07-09 LATEST REVISION DATE  <i>Thomas E. M. Donnell</i> APPROVED BY BRIDGE ENGINEER	
	STANDARD DESIGN - 30' ROADWAY, 3 SPAN BRIDGES <b>CONTINUOUS CONCRETE SLAB BRIDGES</b> NOVEMBER, 2006
	<b>MONOLITHIC PIER CAP DETAILS ALL BRIDGES</b>
<b>J30-24-06</b>	
SHEET 2 OF 2

**TYPICAL CAP SECTION**

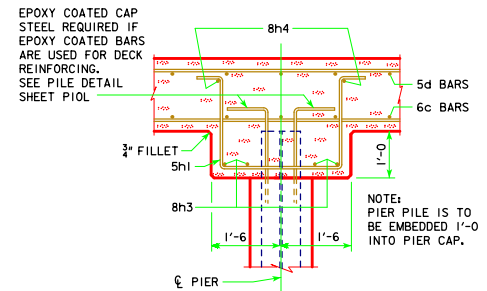
REVISED 07-09 - CHANGED THE DRAIN ANGLES DETAILS ON SECTION A-A.
